Title: TRAVERSE and ASCENT underperforming

Affected Bikes: - all Traverse with M400 motor and Rhino battery
- all Ascent with M400 motor and Rhino battery

Reason: Bikes underperforming due to wrong Controller Firmware and/or Assist Level Settings

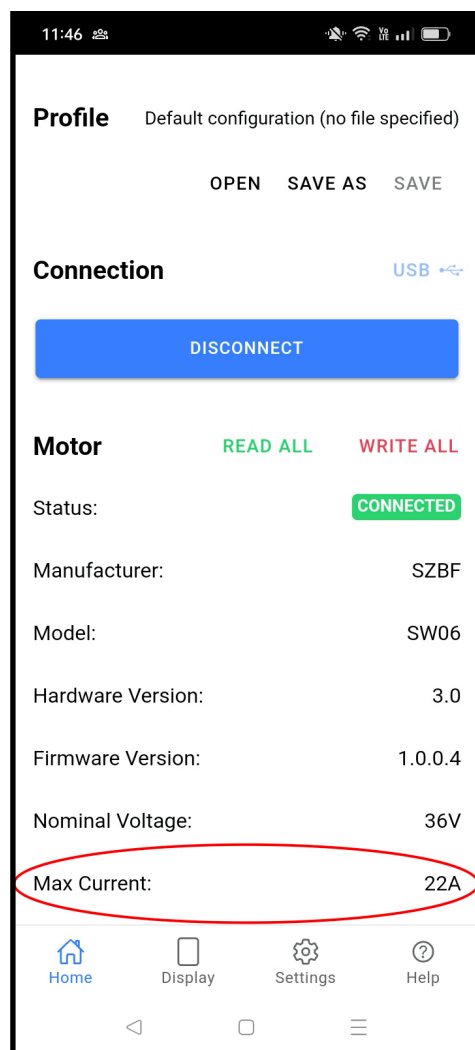
Check version of controller firmware with SPEED App.

In Menu “Home” the Max Current should show 22A (see picture below).

If the Max Current shows 20A, the firmware needs to be updated (contact your Service Manager).
